Urgent Field Safety Notice

Intellis™ Data Validation System Error Model A710 Software Update to Version 1.3.130 Software update

Medtronic Reference: FA949

Figure 1: Validation Error Prompt

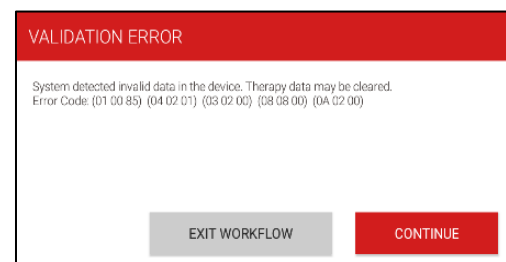
Medtronic has received fourteen (14) reports between January 2020 and November 24, 2020 where users encountered this validation error (Figure 1) followed by a system error (Figure 2) on the CT900 Clinician Programmer A710 Intellis Software Application version 1.3.80 indicating that the stimulator programming update could not be completed. After investigation, it was determined that there was corruption within a specific location of the stimulator memory and the A710 Intellis Software application version 1.3.80 did not clear the corruption as it was designed to, resulting in a system error. This system error is not a frequent event and the occurrence rate has been reported as lower than 1 in 10,000.

This issue occurs and is recognized in the clinical setting where the patient is under the care of the healthcare professional. If you are presented with the VALIDATION ERROR (as shown) with Error Code (01 00 85) (04 02 01) (03 02 00) (08 08 00) (0A 02 00) **before** installing the latest A710 Intellis Software Application v1.3.130, please select the **"CONTINUE"** option. If **"EXIT WORKFLOW"** is selected, please reestablish communication and select **"CONTINUE"** when presented with the VALIDATION ERROR (figure 1).

Please download the latest update to the A710 Intellis Software Application, version 1.3.130, to the CT900 Clinician Programmer following the enclosed instructions.

Figure 2: System Error Prompt

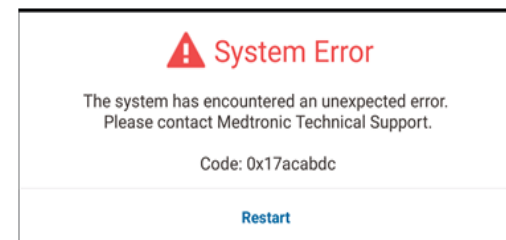
After selecting the **"CONTINUE"** option, if this **"System Error"** (Figure 2) is displayed, please contact your Medtronic representative responsible for your facility or contact our Neuromodulation Technical Scientific Service at Tel. 02159/8149-171 for help in downloading the latest A710 Intellis Software Application v1.3.130. After downloading the newest Intellis Software Application v1.3.130, please reestablish communication and select **"CONTINUE"** to correct this issue.
